## **Road Safety Audits**

#### Stage 1 Road Safety Audit Brief

Anglia Level Crossing Reduction Strategy – Phase 1 & 2

Essex Stage 1 Road Safety Audit Response Report

Figure 2.4: Bulls Lodge Quarry access road.

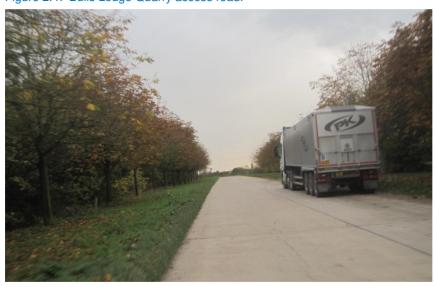
Summary: Pedestrians walking within the carriageway at risk of collisions with large vehicles.

The diversion route guides pedestrians along the Bulls Lodge Quarry access road which is heavily used by large vehicles. Although the access road is wide and has good forward visibility, it is not recommended that pedestrians walk within the carriageway as any collision with a large vehicle is likely to result in serious injury to pedestrians.
